**PLANNING COMMISSION
Regular Meeting
Monday, November 22, 2021
6:00 PM
Christine Nuernberg Hall**

TO: Planning Commission
FROM: PA PHOUALA VANG, PLANNER
DATE: November 22, 2021
SUBJECT: North Shore Bank. The applicant is seeking conditional use grant extension approval for the previously approved bank building with a rear drive-through for the property located at 11319 N. Port Washington Road. This was previously approved in October 2020.

TO: Planning Commission
FROM: PA PHOUALA VANG, PLANNER
DATE: November 22, 2021
SUBJECT: Applied Buildings, LLC. The applicant is seeking building and site plan and fill approval for a proposed 36,843 sq. ft. multi-tenant office/warehouse building and certified survey map approval to allow for a 3-lot land division for the property located a 5715 W. Donges Bay Road.

MEHTA MULTI-TENANT FACILITY
MEQUON, WI
LED SITE LIGHTING PLAN

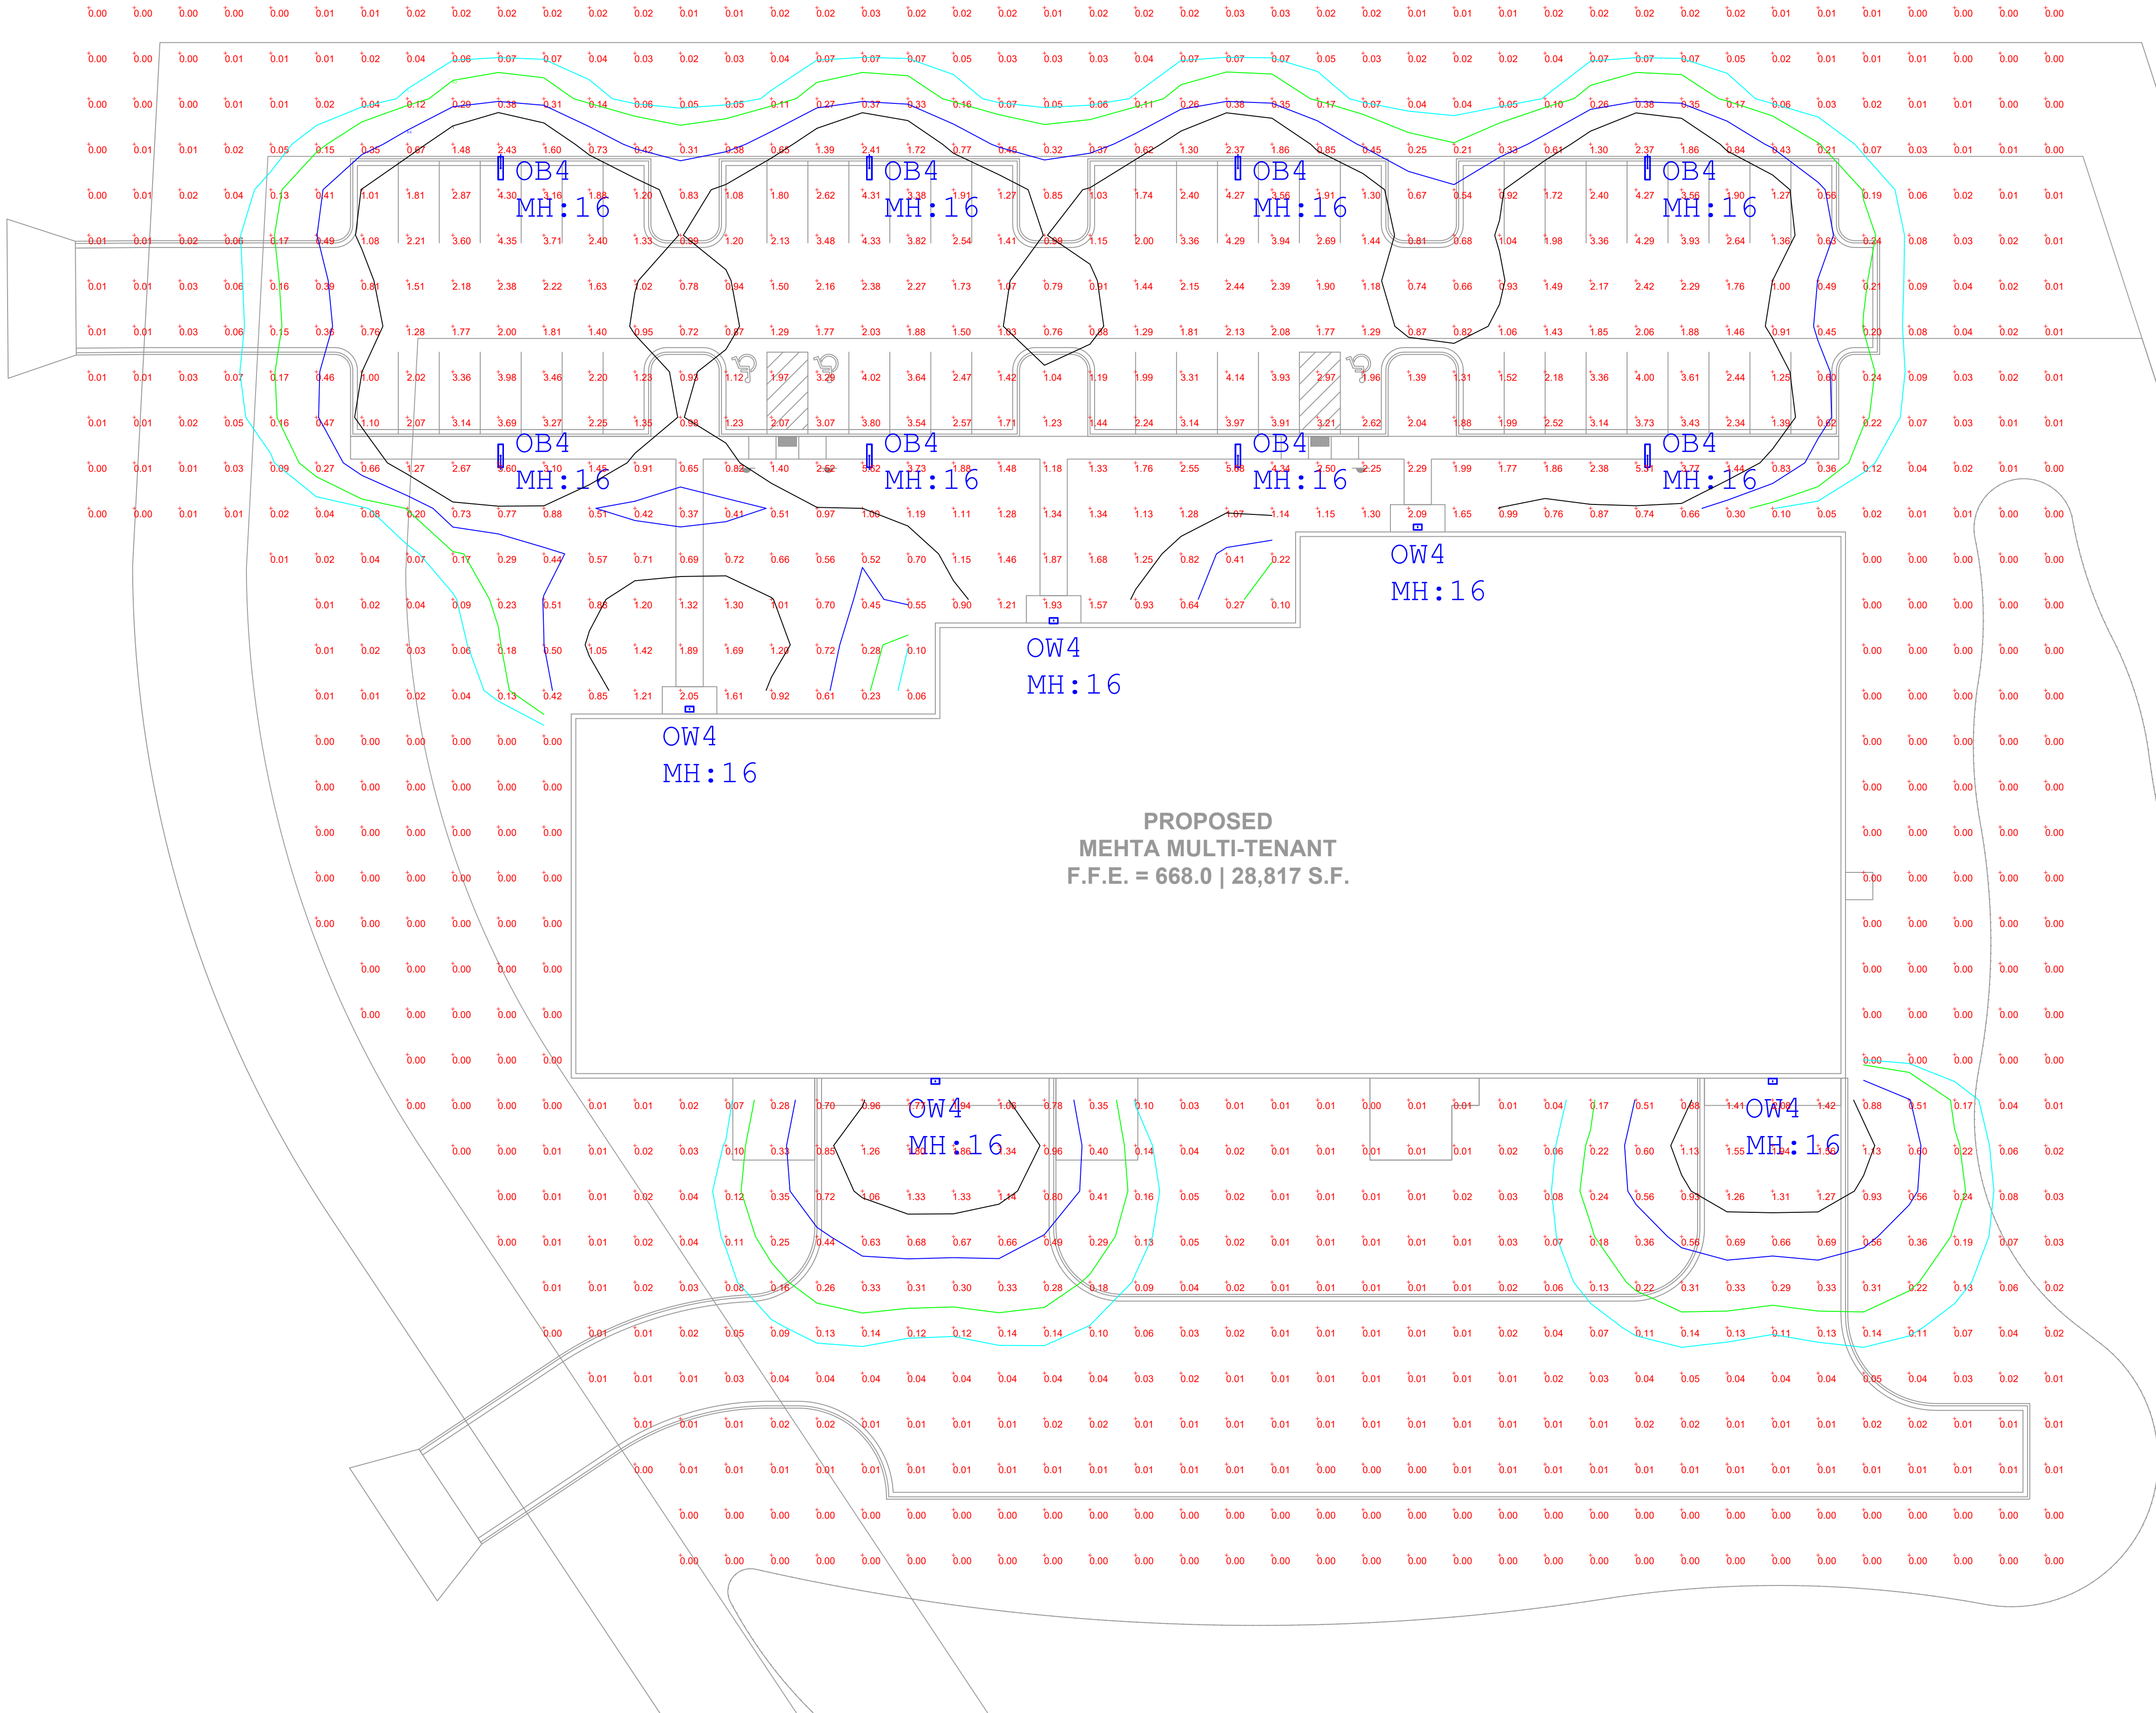
The lighting plan proposes 8 parking lot pole lighting and 5 wall mounted fixtures. The photometrics show a parking area footcandle average of 2.04 FC which meets the code requirement. Parking lot lighting is allowed up to 20 feet in height, except where the parking lot is within 100 feet of a residential use the height shall not exceed 16 feet. The parking lot lighting is proposed at 16 feet in height although the parking lot is not within 100 feet of a residential use.

All fixtures shall be full cut off and meet all requirements of the lighting code. Cut sheets for review and approval by staff is added as a condition of approval.
